RENESAS TECHNICAL UPDATE

Product Category	MPU & MCU		Document No.	TN-RX*-A108A/E	Rev.	1.00
Title	Corrections to Manual regarding the USB 2.0 Host/ Function Module (USBa) in the RX63N Group and RX631 Group		Information Category	Technical Notification		
Applicable Product	RX63N Group, RX631 Group	Lot No. All	Reference Document	RX63N Group, RX631 Group User's Manual: Hardware Rev.1.80 (R01UH0041EJ0180)

This document describes corrections to section 34, USB 2.0 Host/Function Module (USBa) in RX63N Group, RX631 Group User's Manual: Hardware.

Figure 34.13 Timing of BRDY Interrupt Generation

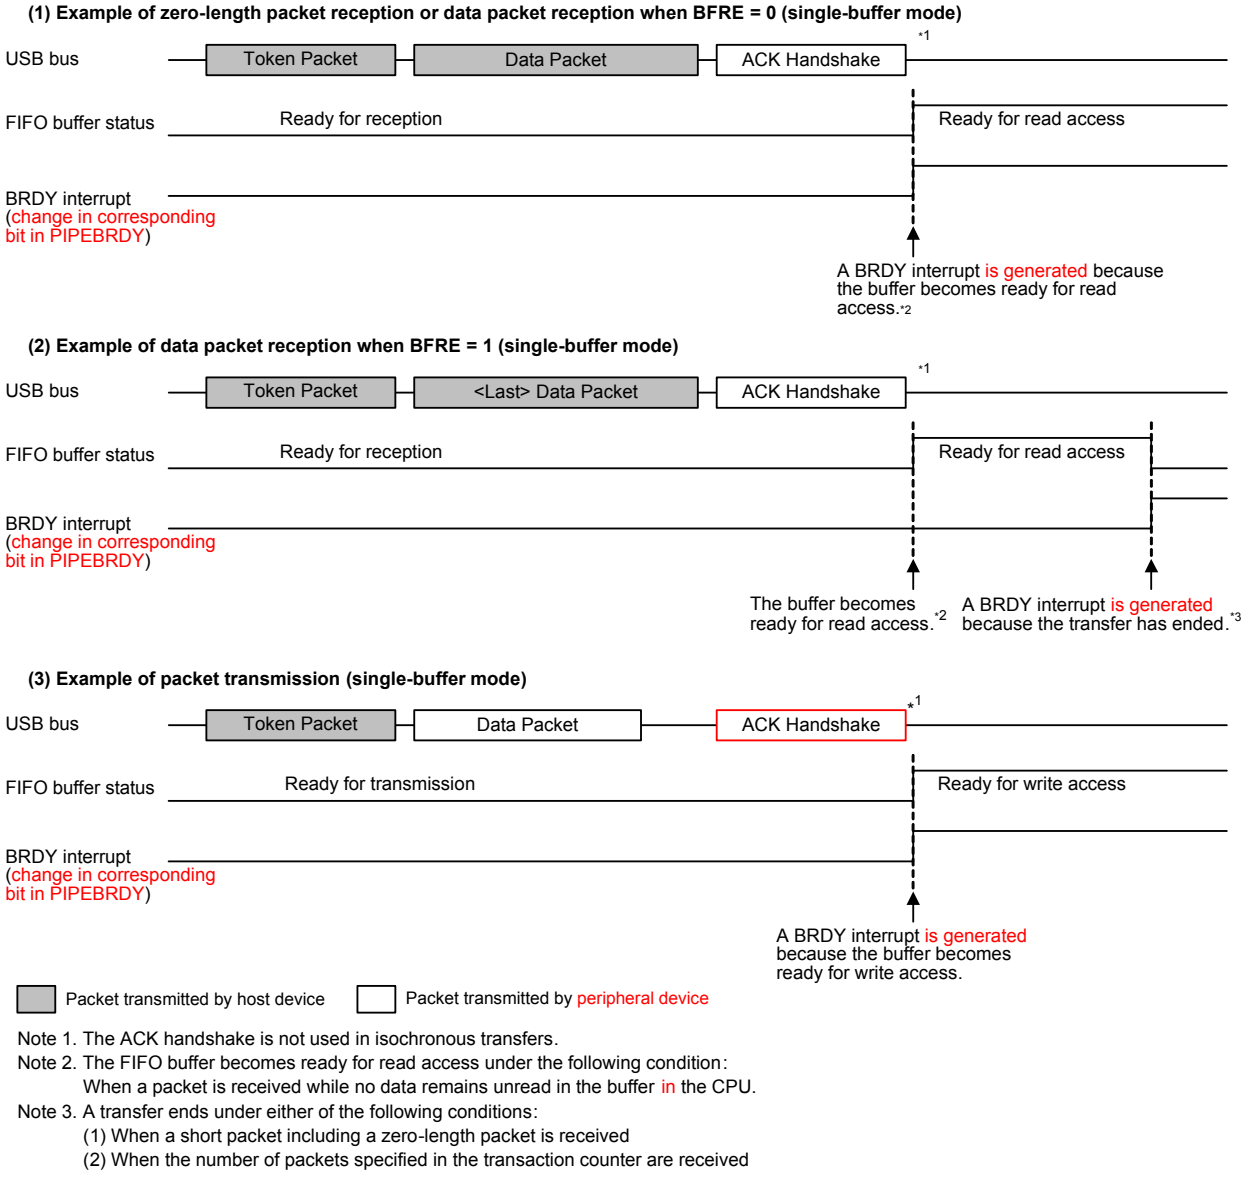
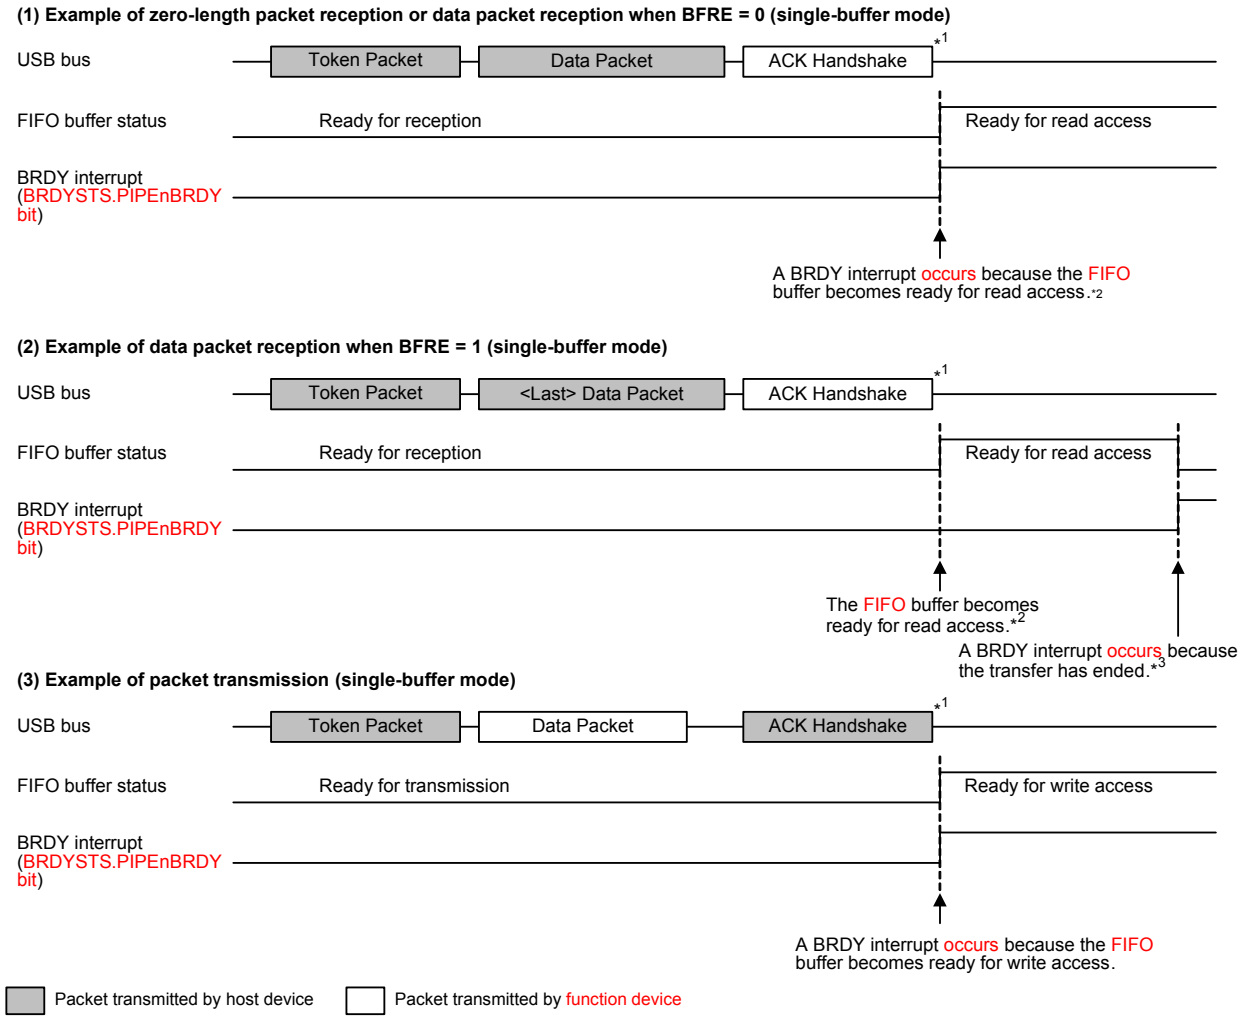
•Page 1283 of 2029

Figure 34.13 is corrected as follows:

Note 1. The ACK handshake is not used in isochronous transfers.
Note 2. The FIFO buffer becomes ready for read access under the following condition:
When a packet is received while no data remains unread in the FIFO buffer on the CPU side.
Note 3. A transfer ends under either of the following conditions:
(1) When a short packet including a zero-length packet is received
(2) When the number of packets specified in the transaction counter are received

Figure 34.14 Timing of NRDY Interrupt Generation (When Function Controller Function is Selected)

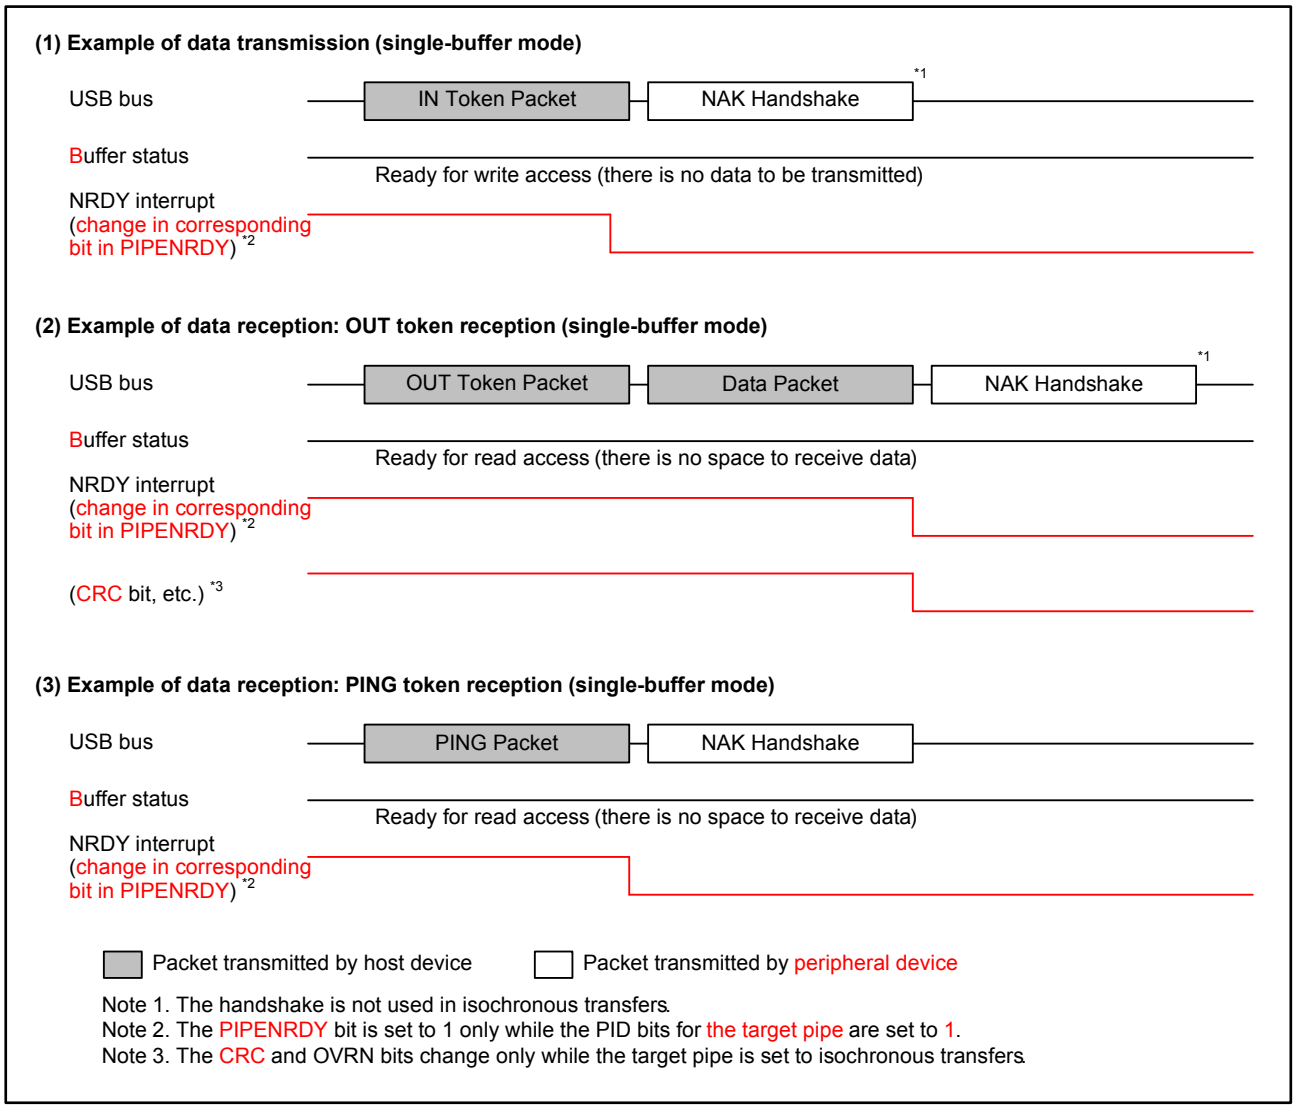
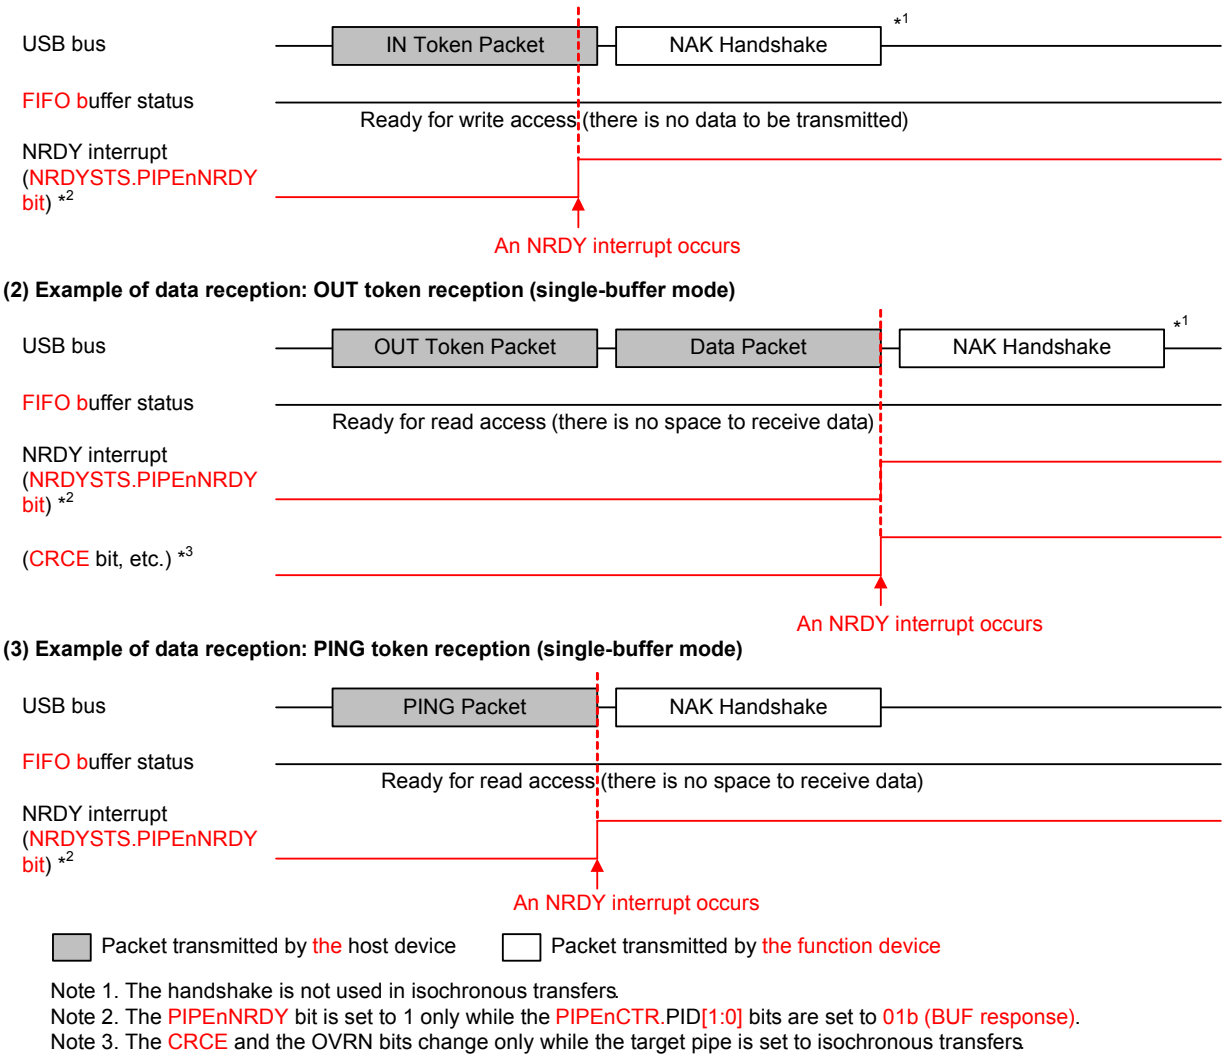
•Page 1286 of 2029

Figure 34.14 is corrected as follows:

Figure 34.15 Timing of BEMP Interrupt Generation (When Function Controller Function is Selected)

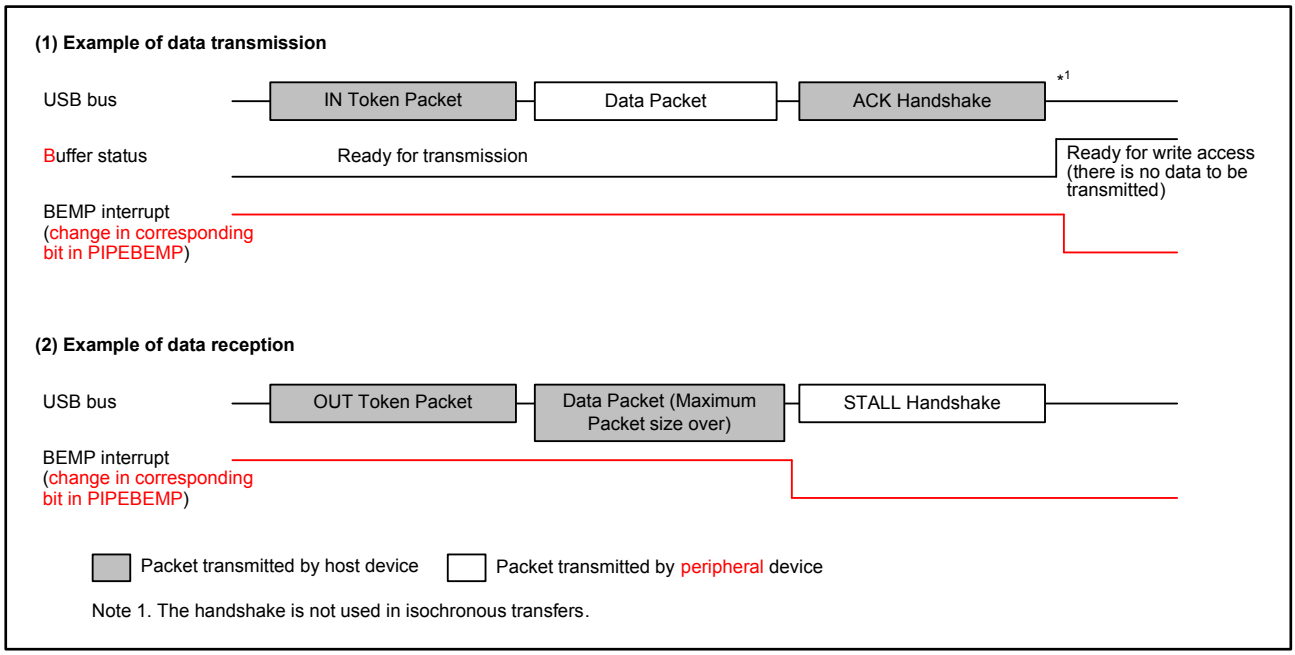
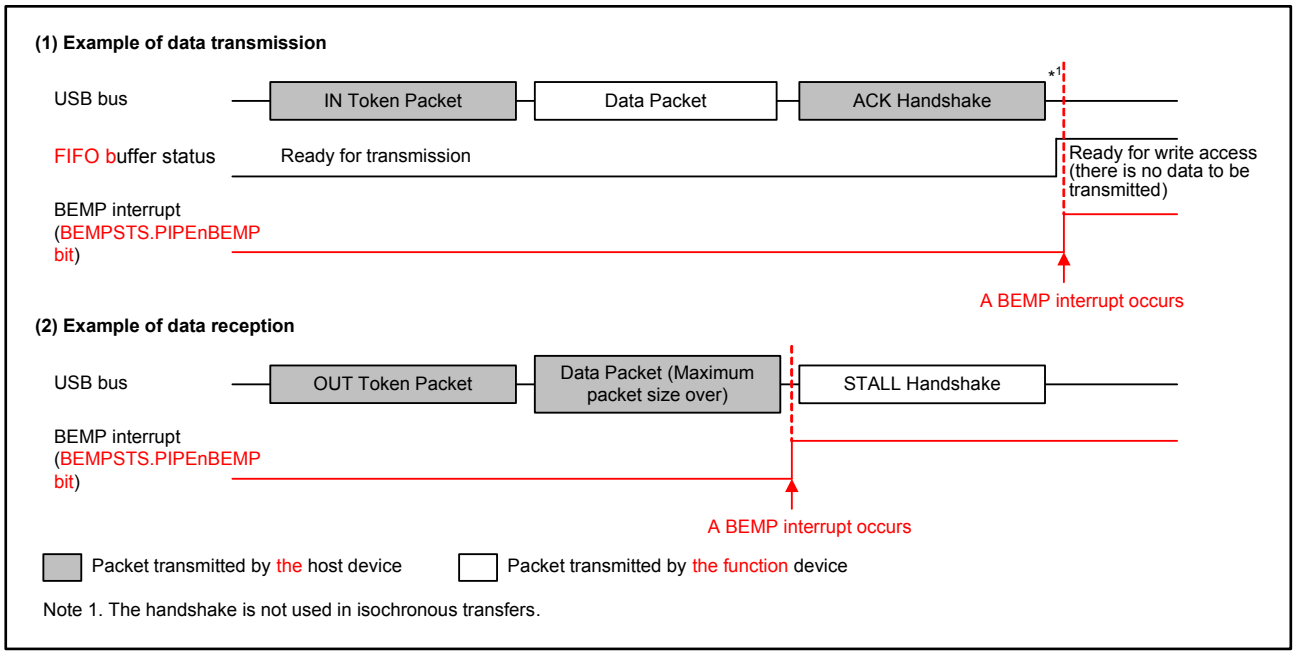
•Page 1287 of 2029

Figure 34.15 is corrected as follows:

Figure 34.20 Relationship between Frames and Expected Token Reception when the IITV = 0

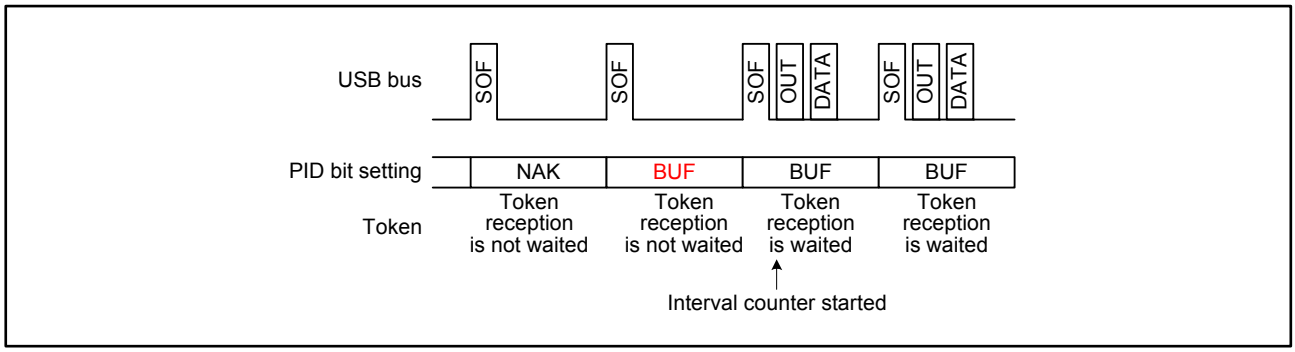
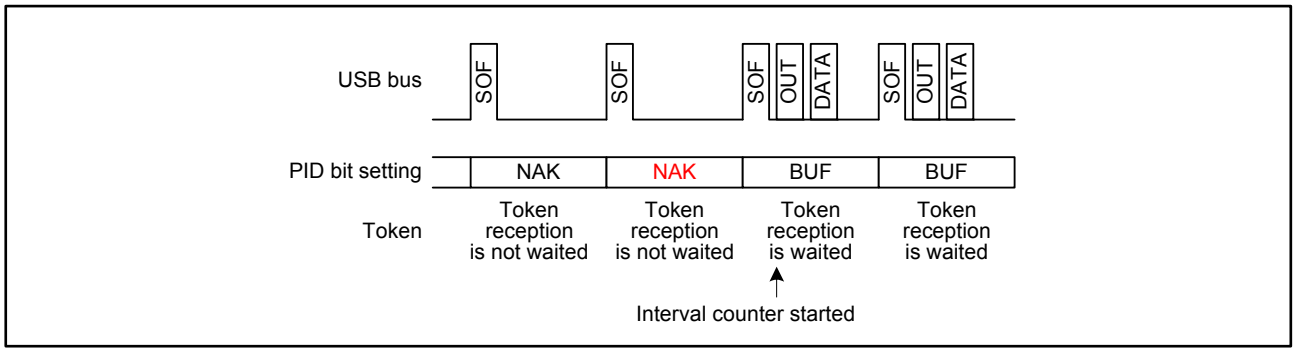
The descriptions for "When the IITV = 0" in 34.3.9.3 (3) (a) and Figure 34.20 are corrected as follows:

- When the IITV = 0: The interval counting starts at the frame following the frame in which software has set the PID[1:0] bits for the selected pipe to BUF.

- When the IITV = 0
  The interval counter starts when software has set the PID[1:0] bits for the selected pipe to BUF.
